**MEETING OF THE DESIGN REVIEW BOARD
MORRIS N. BROAD COMMUNITY CENTER
1175 95TH STREET
BAY HARBOR ISLANDS, FL 33154**

REVISION # 1 REVISION DATE: 07/18/23

Subject: Site Development Plan Application - Revision
Proposed New 9 DU Multifamily Residential Complex
Revisions to Approved Site Development Plan
1055 93rd Street
Bay Harbor Islands Acct. No. SPR22-000026
MMPA Acct. No. 01-0702-1144

Revision to Approved Planning and Zoning Board Submission

Sheet A-13, Level 3 Floor Plan

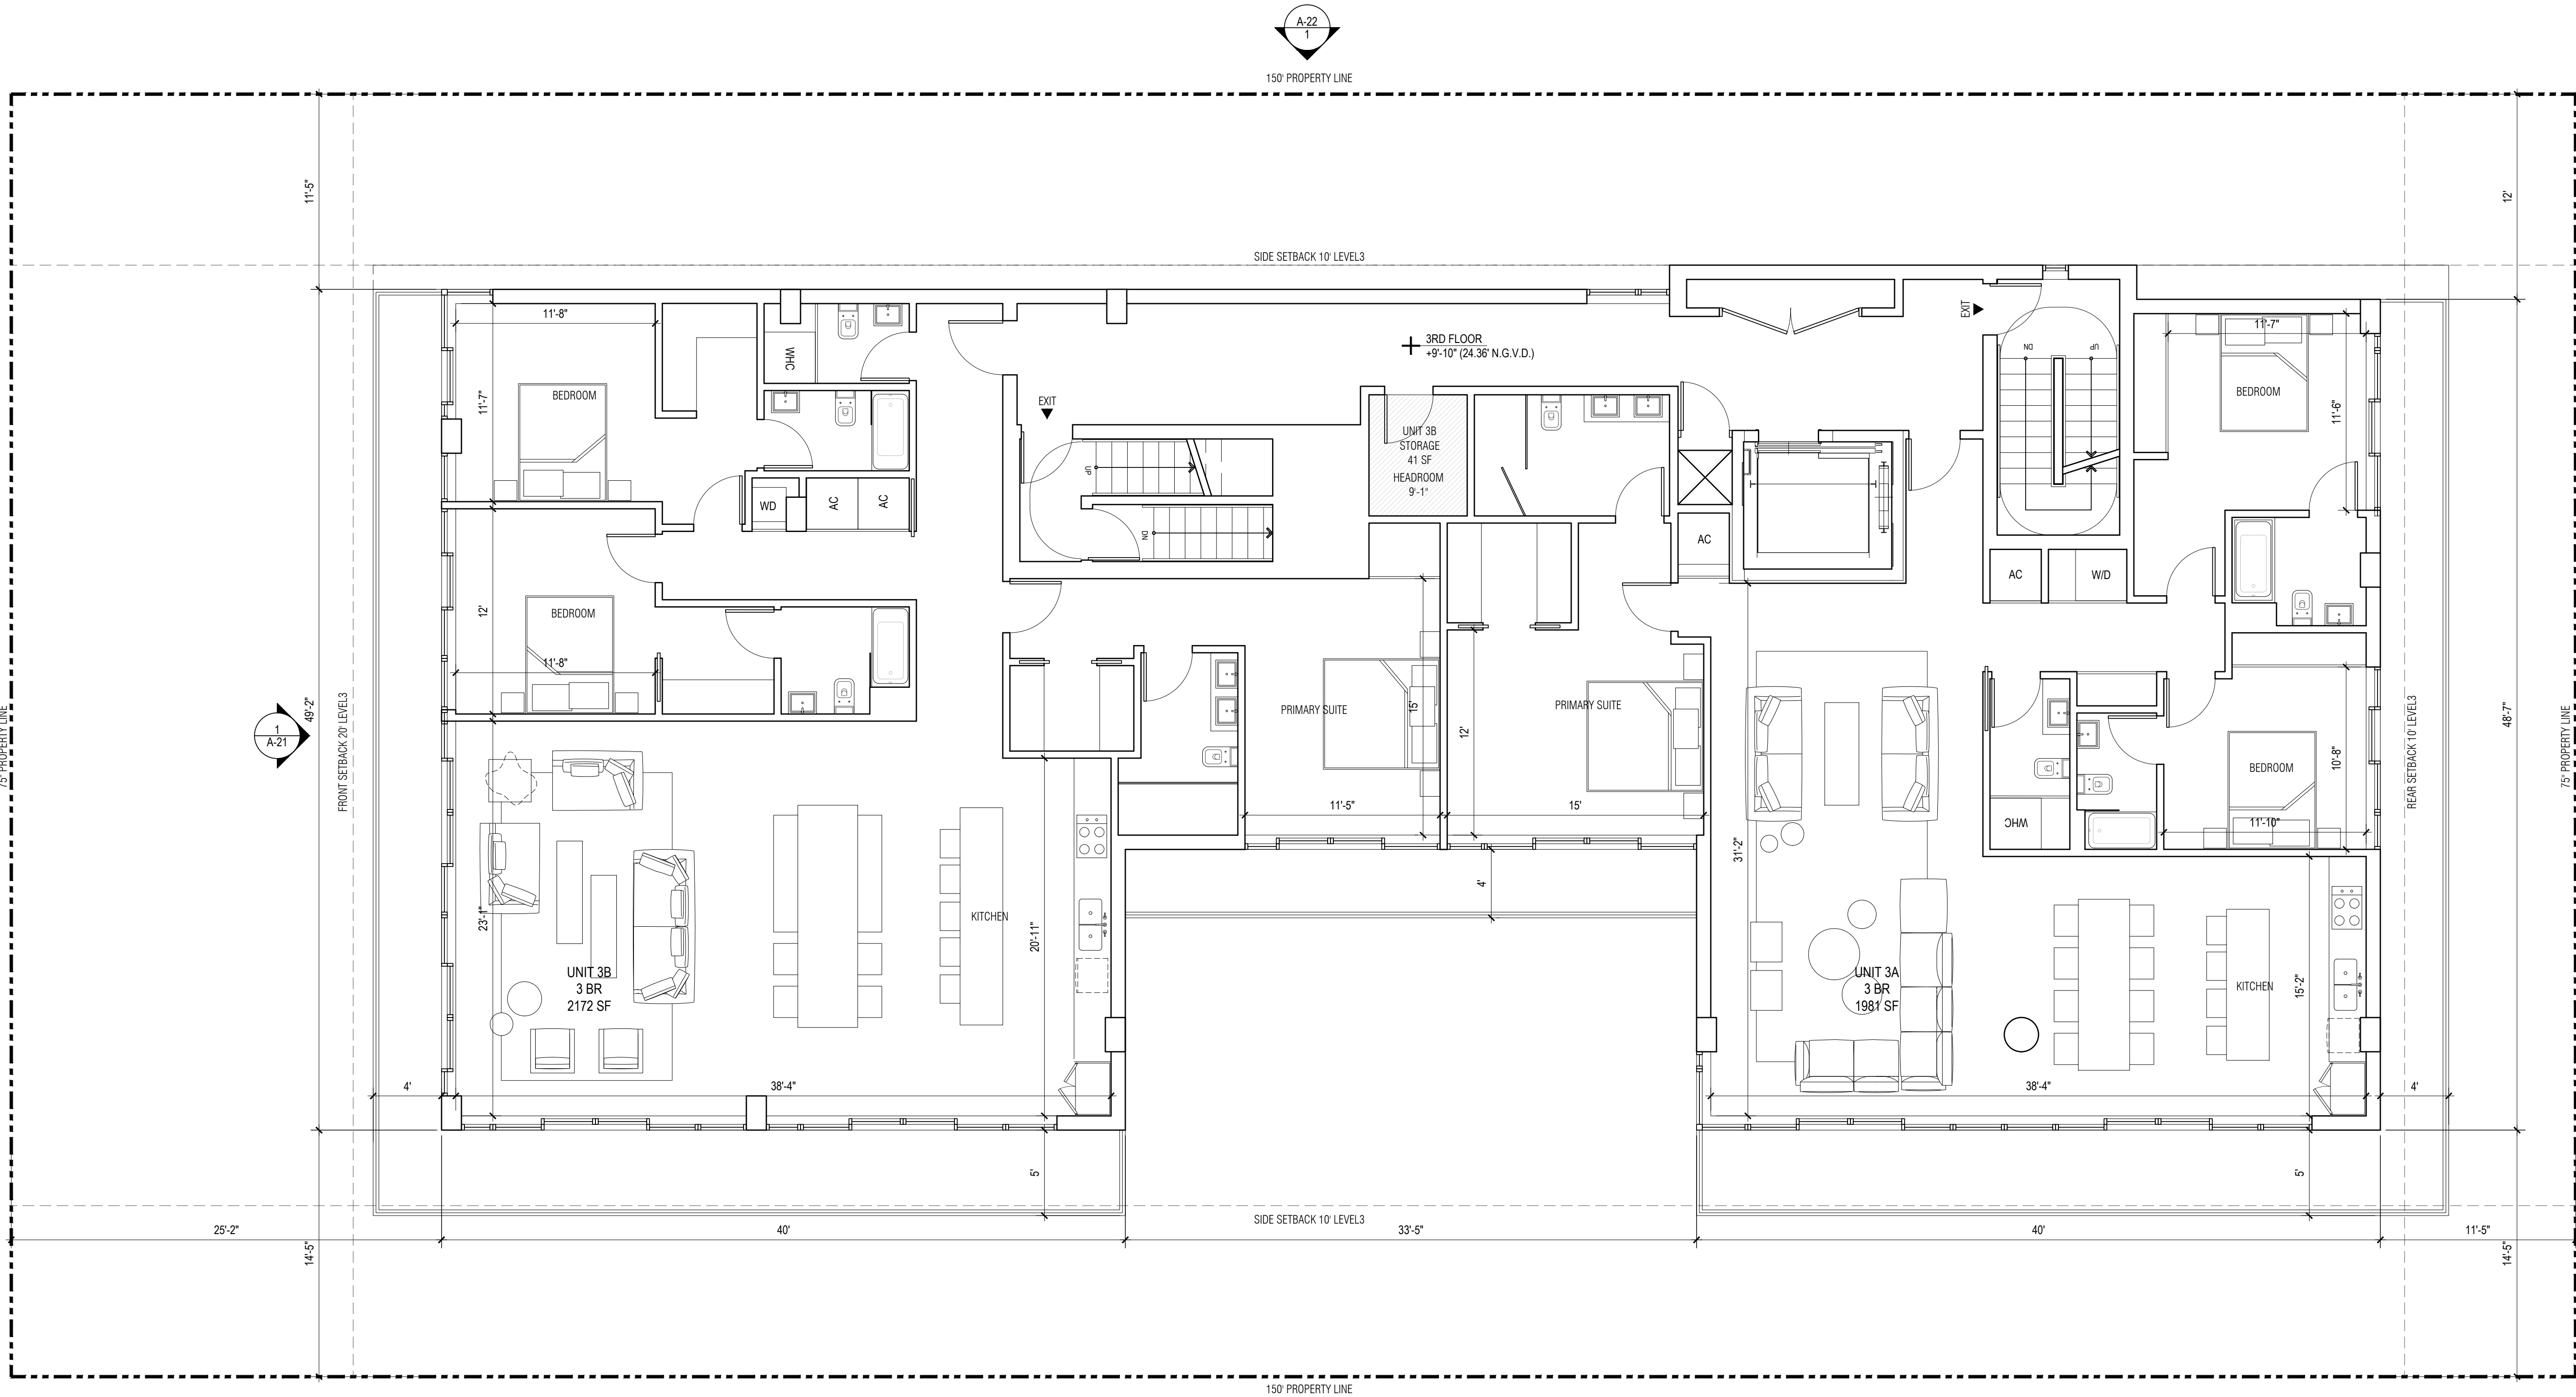
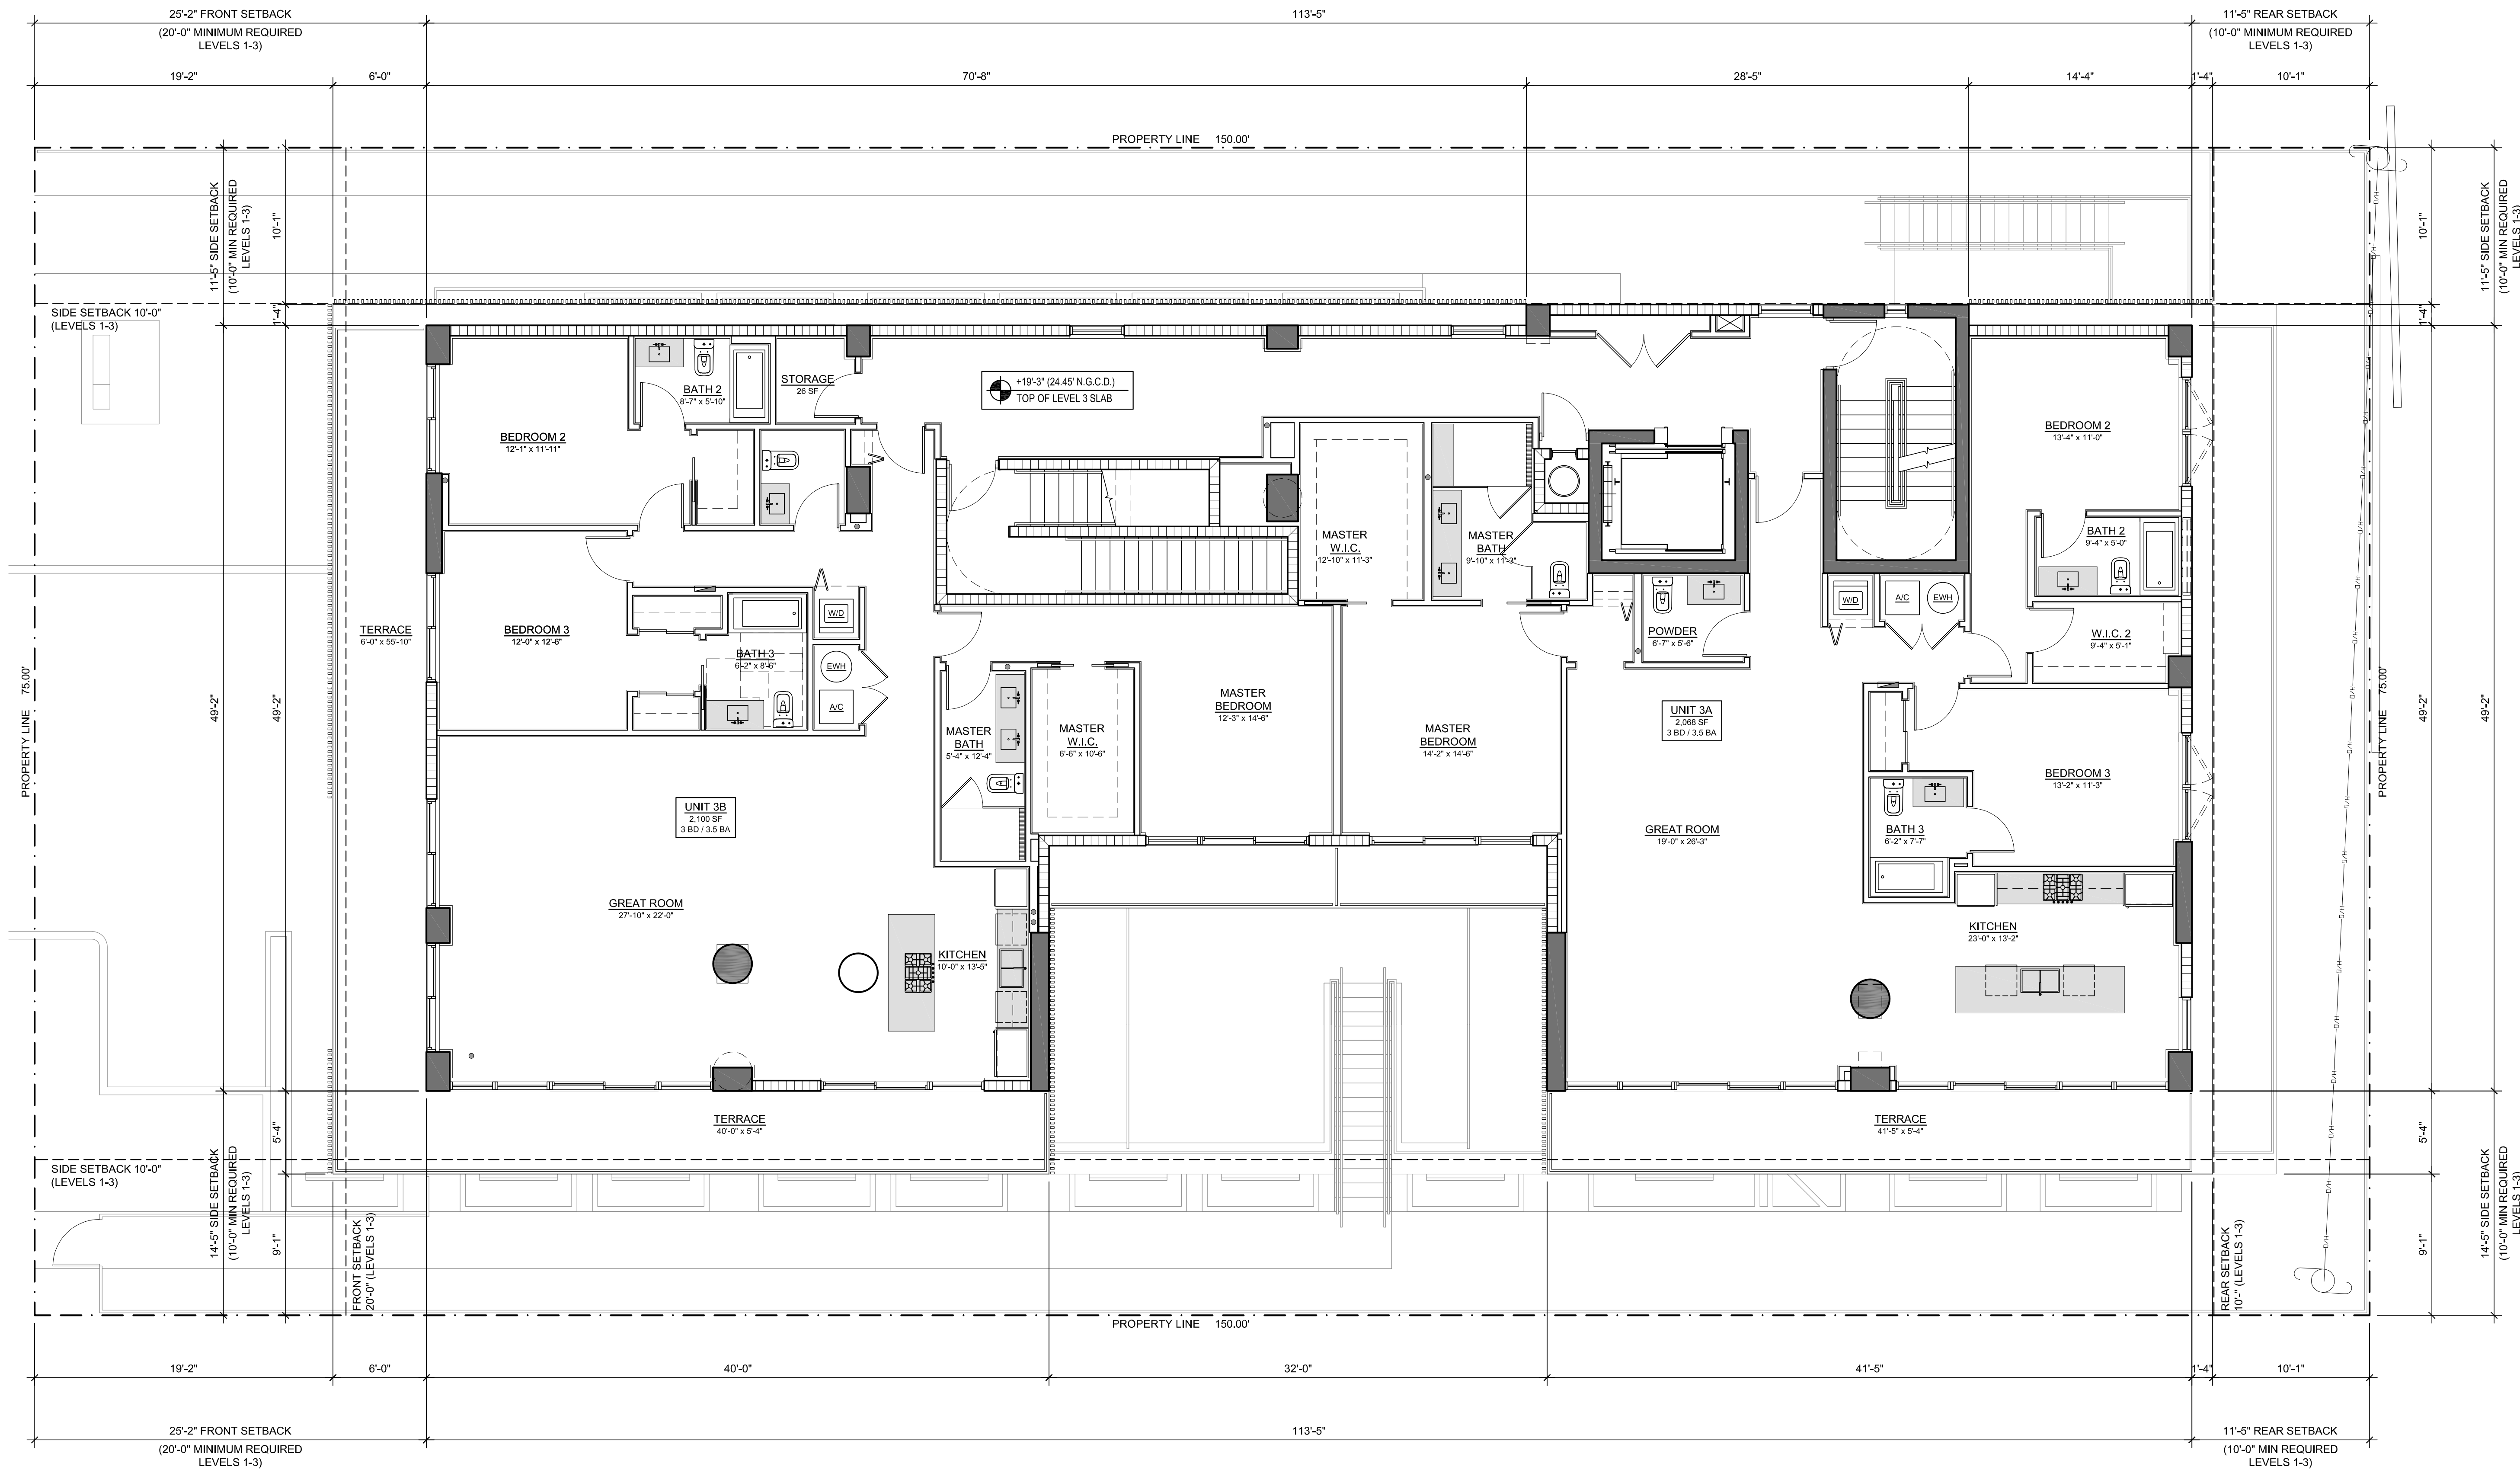
1. Modifications to the floor plan to remove the north facing balcony along the rear elevation due to the proximity of the FPL power lines that are running along the rear property line
2. Modifications to the exterior window/door placements and sizes due to changes to the unit layouts and coordination with Structural
3. Modifications to the interior unit layouts
